STATE OF MAINE
DEPARTMENT OF TRANSPORTATION
16 STATE HOUSE STATION
AUGUSTA, MAINE
04333-0016

December 28, 2006
Subject: **Topsham**
Pin No. 14062.11
Amendment No. 2

Work under this contract is generally described as the construction of the MaineDOT TOPSHAM HIGHWAY MAINTENANCE GARAGE

DATE 12-11-06	SCALE AS SHOWN	JOB NO LP ENG 300-01-06	DRAWING NO P-4
BY L. P. Pelletier	CHKD

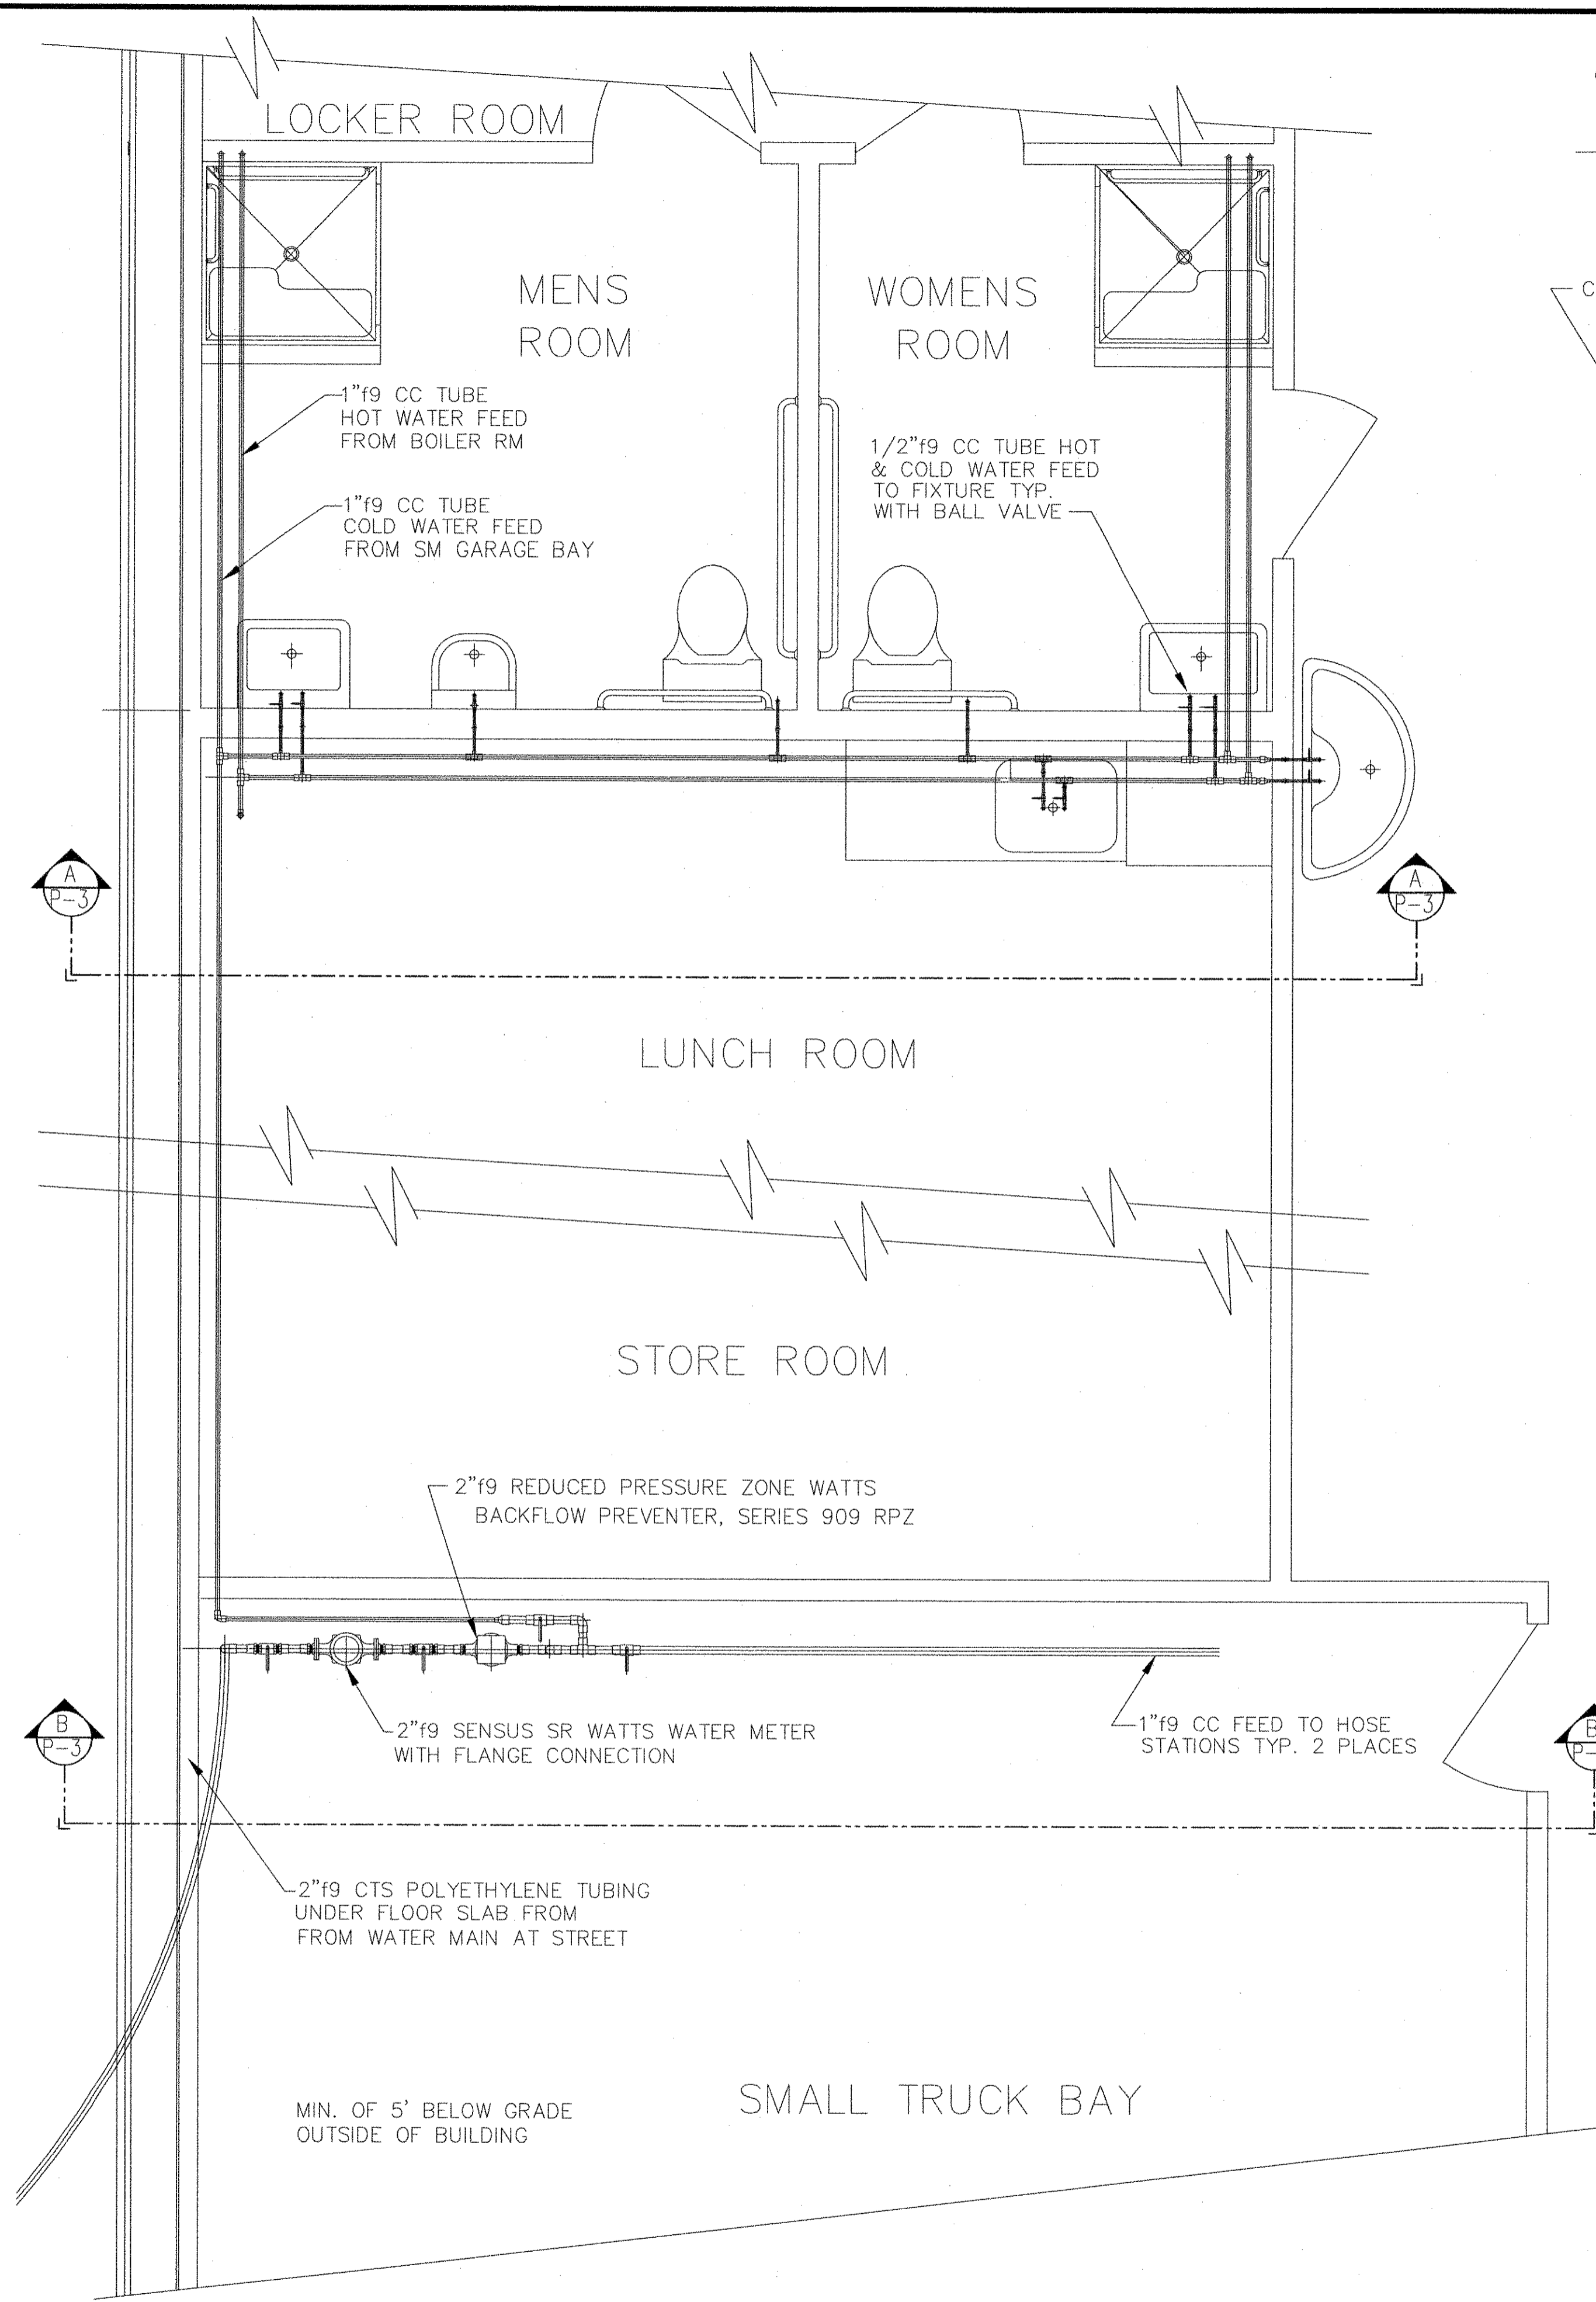
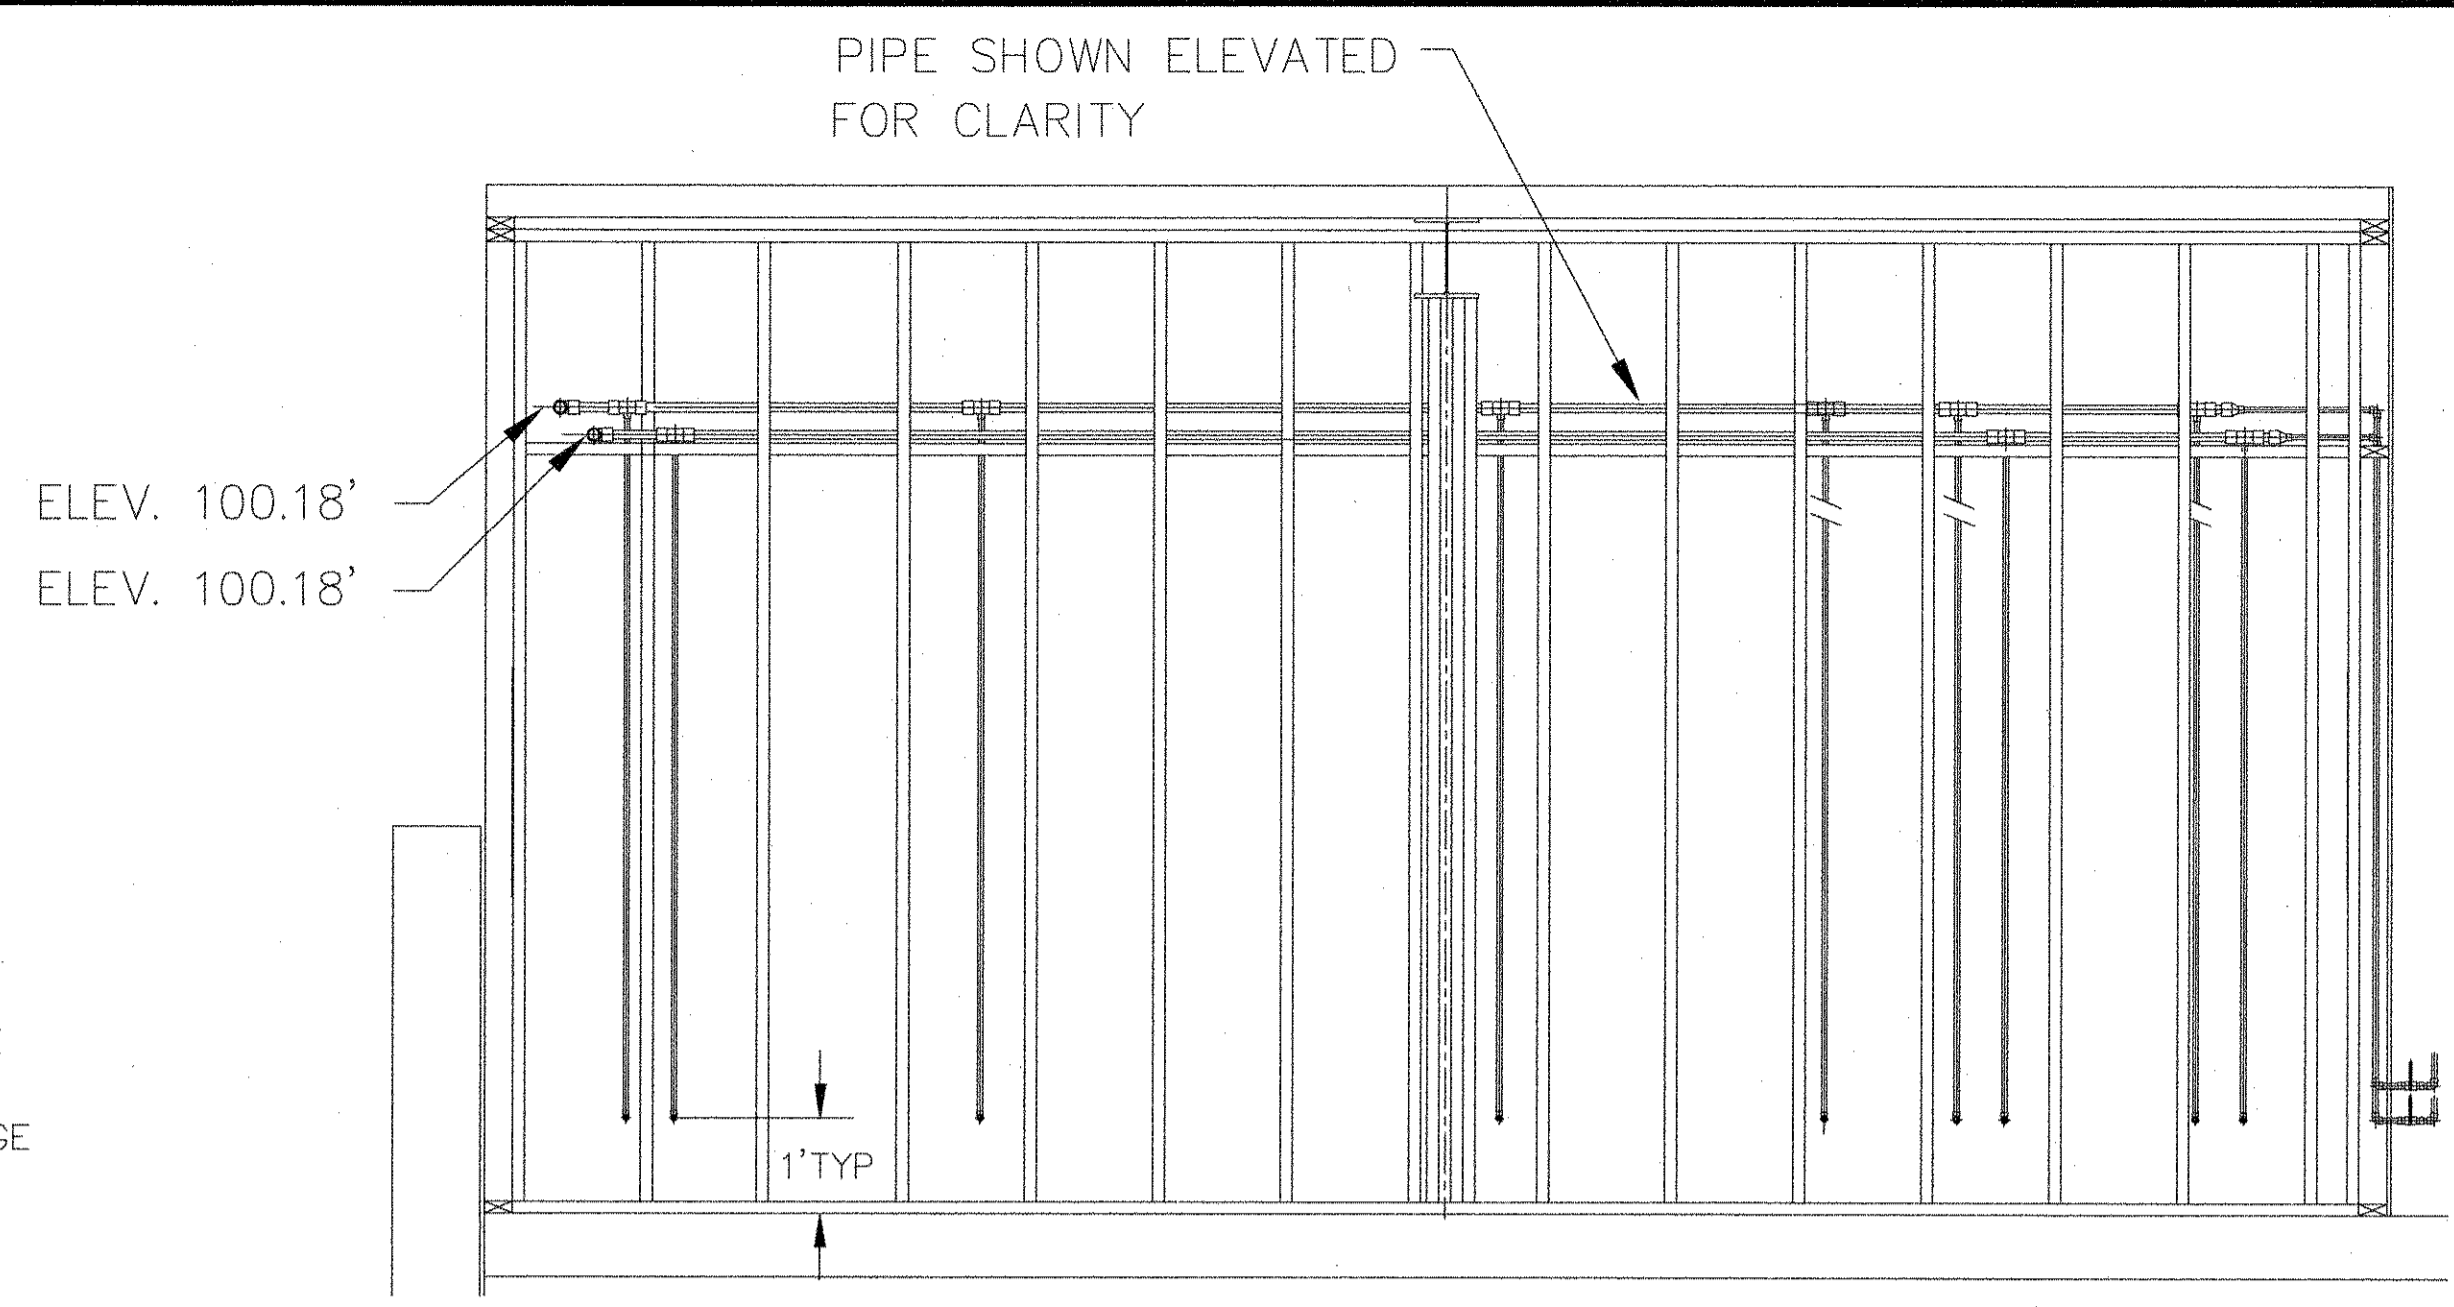
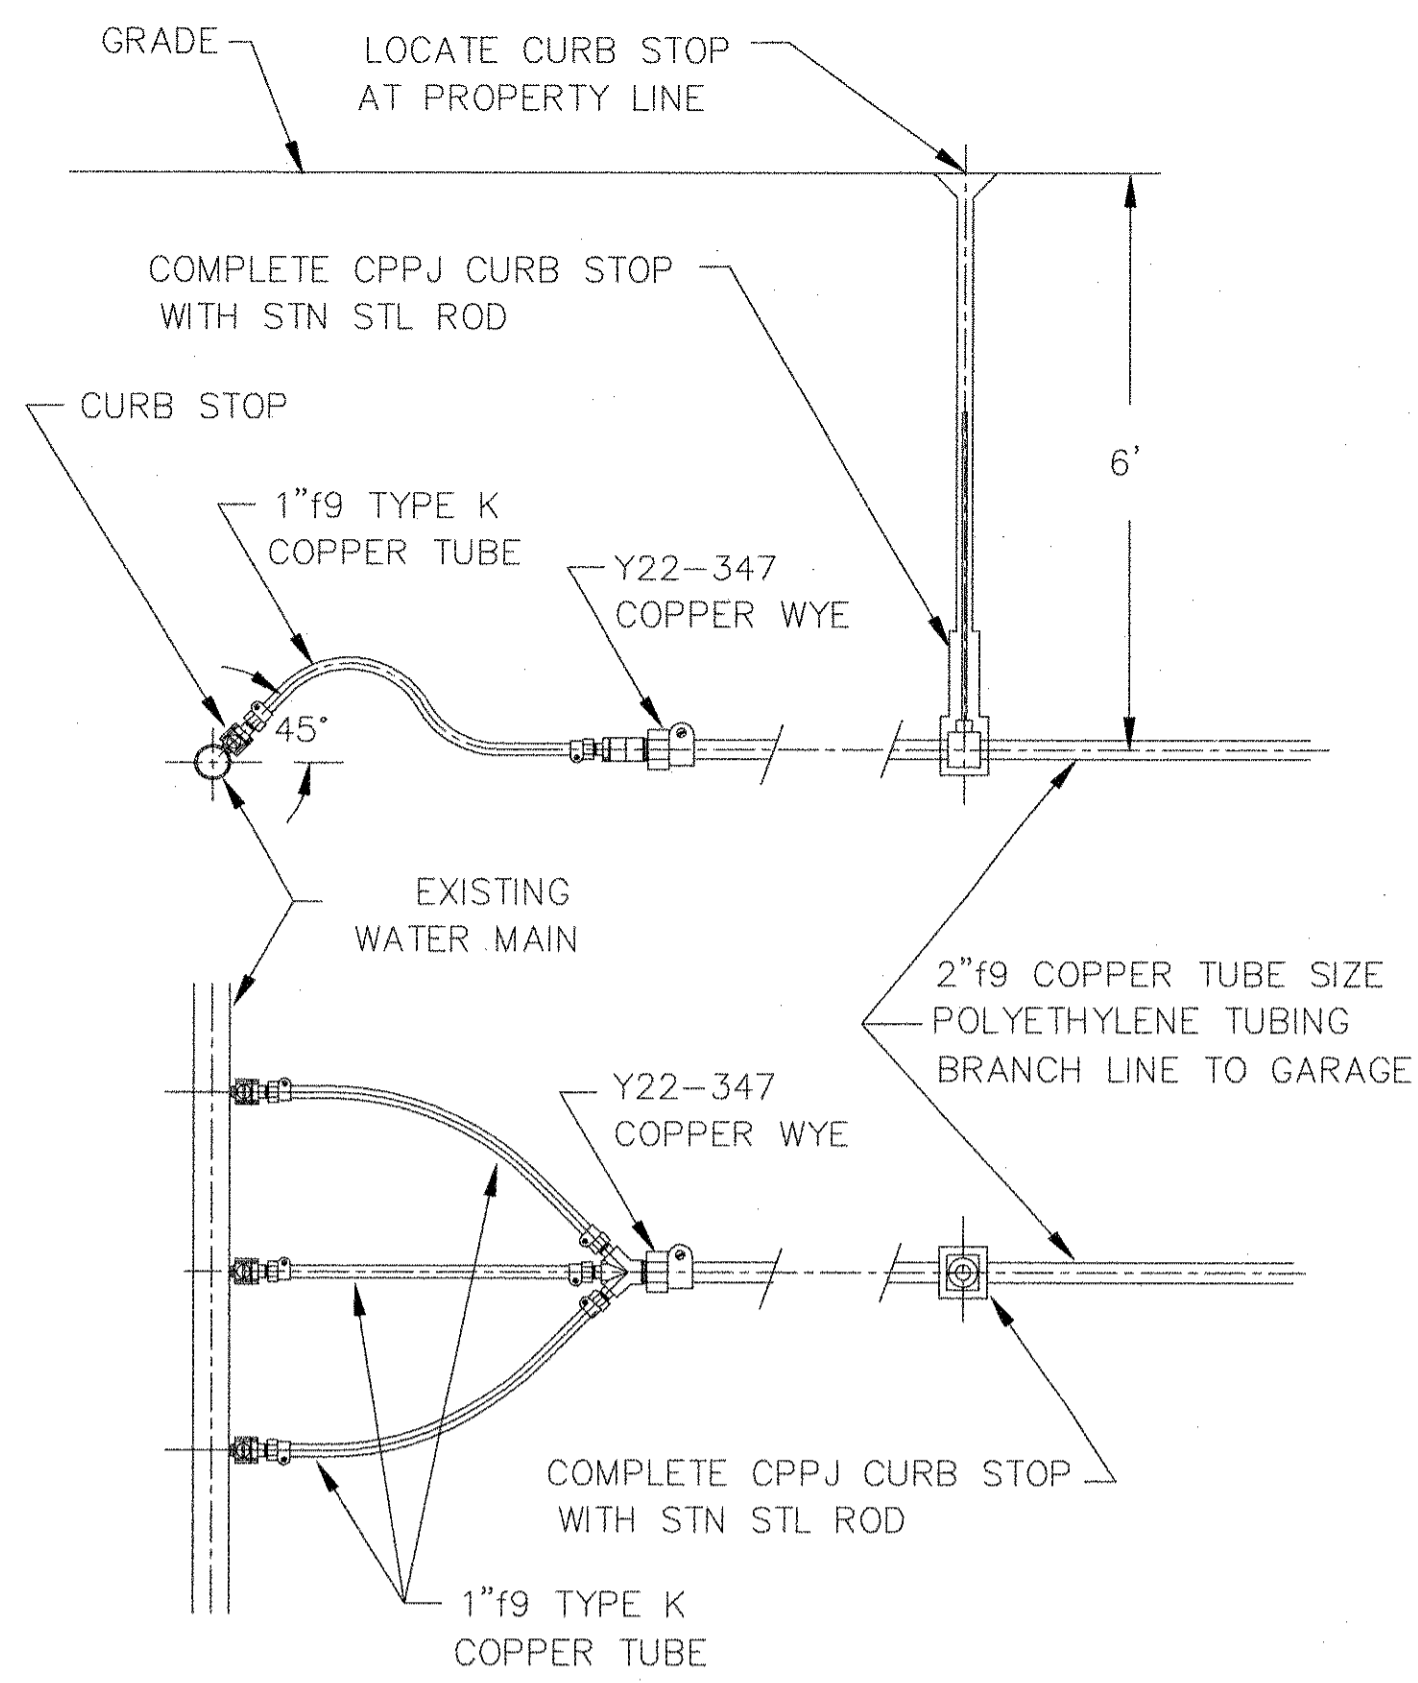
Question: There is no Domestic Water Plan/Sizing/Layout.

Question: Are there any hose bibs required in the garage space/wash bays?

Response: This is shown on the new attached Drawings P-3 and P-4.

Response: There are hose bibs and they are shown on the added attached drawing P-4.
